# **RANGEVIEW ESTATES**

Urban Transportation Considerations  
City of Mississauga  
Official Plan Amendment (OPA)

### RESPONSES TO COMMENTS REGARDING BA GROUP'S MAY 31, 2024 TRANSPORTATION REPORT (OPA)

1. City of Mississauga (OPA) - July 10, 2024
2. HDR Peer Review comments (OPA) - December 13, 2024
3. Region of Peel Comments (OPA) - November 22, 2024

FIGURE 38 - Pedestrian Site Traffic Volumes to Future BRT – Scenario 1 (2031)

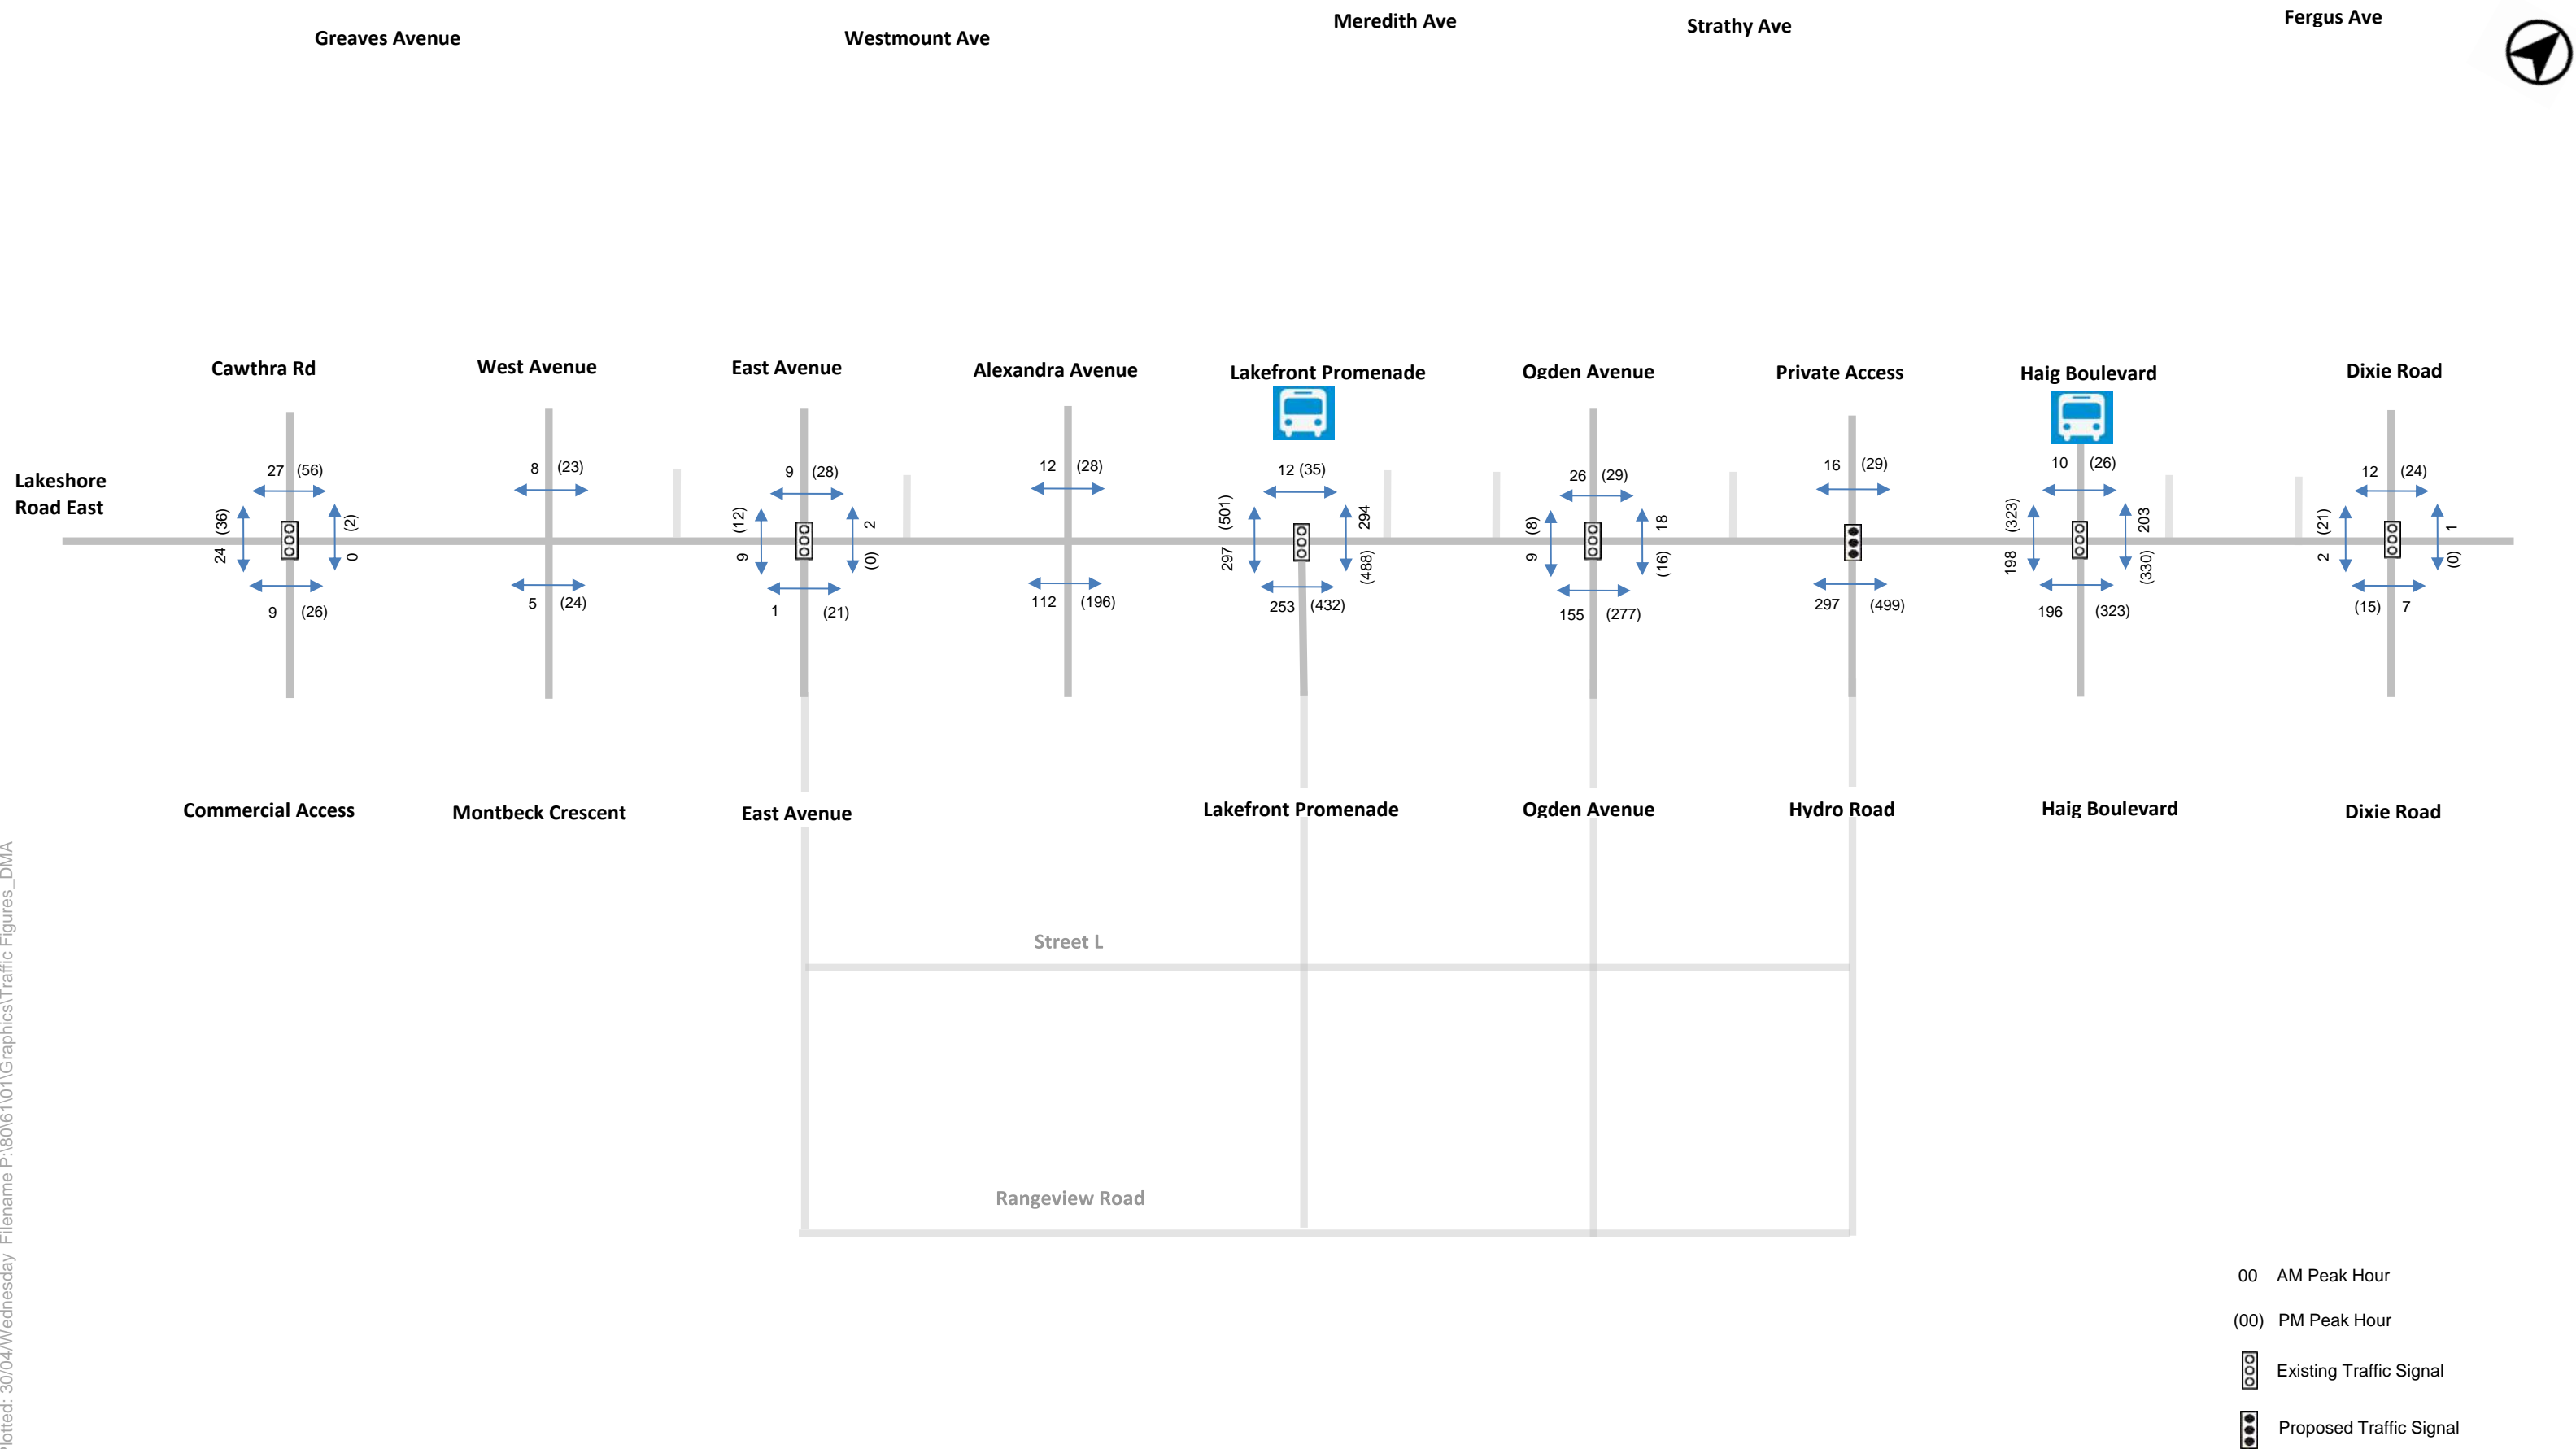
- b. Dixie Rd in SB direction should not be coded as 2 lanes, please confirm that the assumption made in the model does not impact results. In addition the SB direction geometry does not match the assumptions highlighted in Figure 38 in the report

- c. The geometry at the intersection of Lakeshore Rd and East Ave in the NB direction does not match the assumptions highlighted in Figure 38.
- d. The geometry at the intersection of Lakeshore Rd and West Ave/ Montbeck Cres does not match the assumptions highlighted in Figure 38.

- a. The VISSIM coding parameters identified in BA Group's Report have been reviewed and no discrepancies between the report and the model were found.
- b. As the traffic analysis confirms that the SBR at Lakeshore Road/ Dixie Road will be very busy in the future, in order to accurately capture the magnitude of the queueing, the 2 lanes have been extended to avoid starvation upstream.
- c. Figure 38 has been corrected for the northbound approach under existing conditions at Lakeshore Road/ East Avenue.
- d. The geometry at the intersection of Lakeshore Road/ West Avenue/ Montbeck Crescent, has been revised in Figure 38.
- e. The VISSIM model has been expanded to include the internal site network. The updated traffic analysis demonstrates the impact of the development at the internal intersections as best as possible with the current
